**AGENDA**  
**CITY OF LAKE WORTH BEACH**  
**HISTORIC RESOURCES PRESERVATION BOARD REGULAR MEETING**  
**CITY HALL COMMISSION CHAMBER**  
**WEDNESDAY, JUNE 14, 2023 -- 6:00 PM**

- C. [HRPB Project Number 23-00100112: Consideration of a Certificate of Appropriateness \(COA\) for the construction of a new ±1,881 square foot single-family house and a new ±693 square foot detached garage at 224 North L Street. The subject property is located in the Medium Density Multi-](#)

Proposed Front Elevation

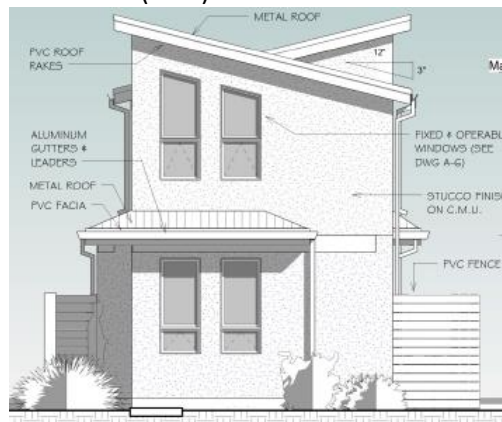
**Analysis:** The proposed design places the entrance on a side elevation rather than on the front elevation, with a covered side porch and walkway to the public sidewalk. The surrounding homes have a variety of entrance and porch configurations, with front doors and front porches placed both on the front and the side of nearby homes. Unlike neighboring properties with entrances oriented to the side, staff contends that the proposed design does not provide sufficient detailing or architectural features; as a result, the front of the building reads as a side elevation facing the street rather than as the primary façade. Furthermore, the porch roofs over the first story of the main house and accessory structure should be revised to be flat roofs, which are more appropriate for the Contemporary architectural style; the porch roof eaves should also be adjusted so that they are the same depth along all elevations of the structure.

**Analysis:** The primary structure proposes to use shed rooflines, with the middle section of the structure at an opposing angle from that of the front and rear of the structure. The detached garage proposes to use a gable roof. The design also proposes a hipped roof above the first story on both the primary and accessory structures. Staff recommends revising the roofline of the primary structure to be a shed roof with a single slope (this would require some alterations to the proposed windows on the second floor) or to change the middle section's shed roof to a flat roof. Staff also recommends revising the hip roof above the first floor to be a simple, flat roof above any porches or areas that the second story is recessed from the first story's exterior walls. The first-floor porch roofs should also be revised so that their eaves are the same depth across all elevations. The gable roof on the rear accessory structure should be revised to be a simple flat roof or a shed roof with the same slope as the primary structure.

**Analysis:** The design of the structure is modern in nature, incorporating elements of the Mid-Century Modern and Contemporary architectural styles. However, as currently proposed, the purity of the modern style is not reading clearly in the architectural design. Other architectural styles may read better on the proposed plan. If the applicants want to pursue a Contemporary design, staff contends that changes to the design are needed to properly convey that architectural style.

Finally, staff has concerns about the proposed design of the front façade. Staff contends that the current design reads more like the side of a building facing the street, rather than the front of a house. While some homes nearby have their primary entrances on the side of the building, they all have sufficient detailing and architectural features to read as the front façade. Staff recommends that the applicant either revise the proposed design to place the entry door on the front façade, or add architectural interest to better emphasize the front façade.

- 1) The main roofline of the primary structure shall be revised to make the middle section a flat roof, or to make the entire roof a shed roof with a single slope.

- 2) The accessory structure shall be revised to have a flat roof.
- 3) The first-story roofline over porches and recessed areas of the primary structure and accessory structure shall be revised to be a flat roof, with eaves of equal depth on all elevations.

- 4) The front façade of the primary structure shall be revised to include the entry door and/or architectural detailing to emphasize it as the main façade of the building.

- 5) The fenestration pattern on the side elevations shall be revised so that openings are centered within the bays and are symmetrical.
- 6) The front door and bathroom windows may utilize clear glass, frosted glass, or glass with a Low-E coating (60% minimum VLT). Tinted, highly reflective, grey, colored, etched, or leaded glass shall not be used.
